DATE: October 3, 2018

AGENDA ITEM #3

TO: Design Review Commission
FROM: Steve Golden, Senior Planner
SUBJECT: 18-SC-01 – 1515 Oakhurst Avenue

PROJECT DESCRIPTION

The image below is contains the trees and their relative locations with corresponding numbers. Take from the Site Plan A1.0. not to scale.

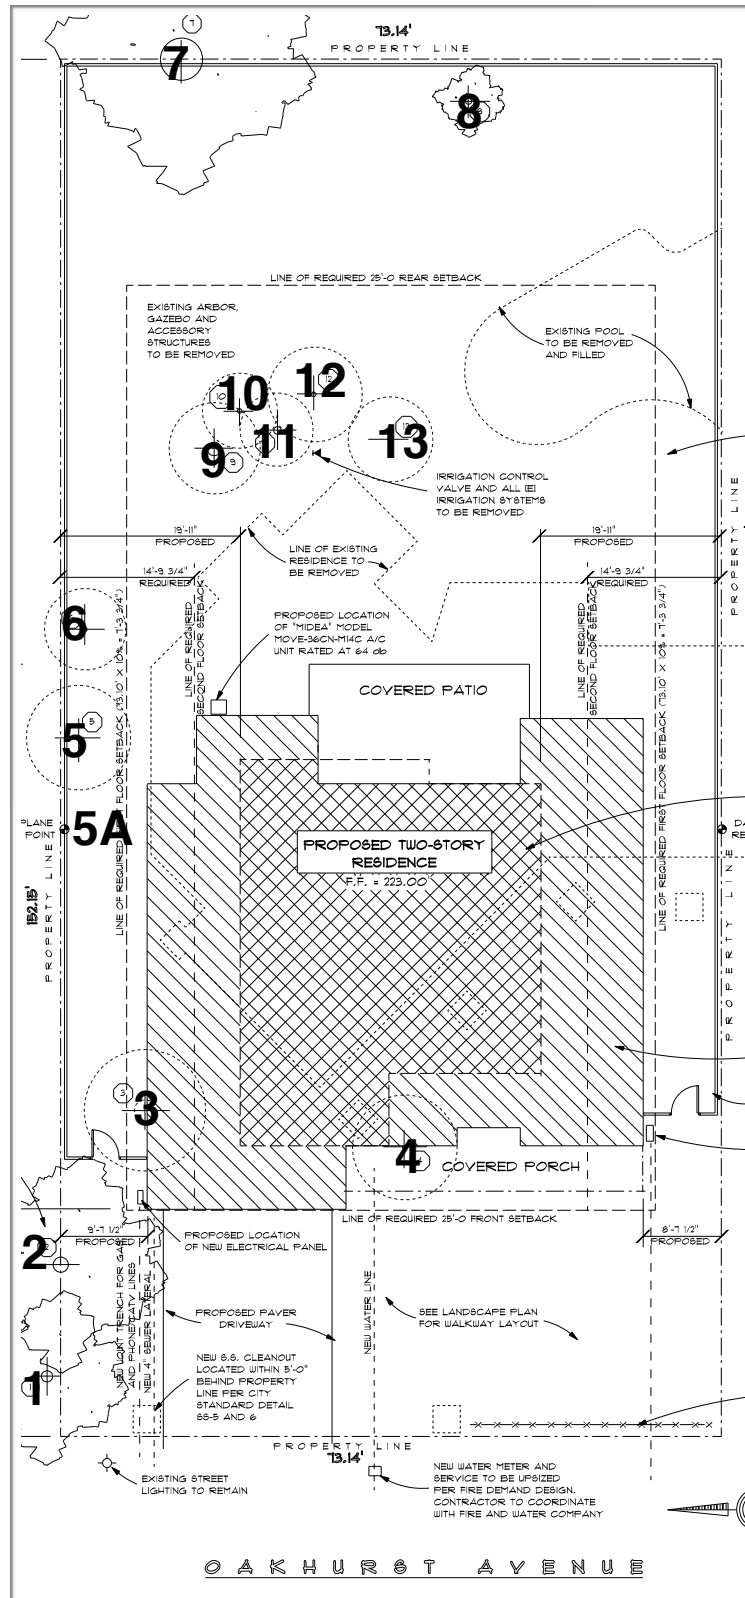
The proposed plans indicate there is an infiltration/evaporation pond under the two coast live oaks #1 and #2, this will need to be relocated. The house footprint is on top of Atlantic cedar #3. All the trees are listed to be removed except for coast live oaks #1 and #2 (originating on the adjacent site) and #7 in the back of ht property. The Atlantic cedar would require 24 feet of radial clearance to be retained. Due to the constraints of the lot I am not certain this tree can be retained and a new residence can be built because of the required tree protection zones between both the cedar #3 and coast live oak #7. The Atlantic cedar could meet the findings for removal as stated in “Section 11.08.090 - Determination on permit” subsections 1, 2, 5 and 7.

1. Place tree numbers and protection schemes on all the plans.
2. Obtain all necessary permits prior to removing or significantly altering any trees.
3. Place tree protection fence around Coast live oaks #1 and #2 at a radius of ten feet.

4. Place tree protection fence around coast live oak #7 at a radius of forty feet.
5. All tree maintenance and care shall be performed by a qualified arborist with a C-61/D-49 California Contractors License. Tree maintenance and care shall be specified in writing according to American National Standard for Tree Care Operations: *Tree, Shrub and Other Woody Plant Management: Standard Practices* parts 1 through 10 and adhere to ANSI Z133.1 safety standards and local regulations.
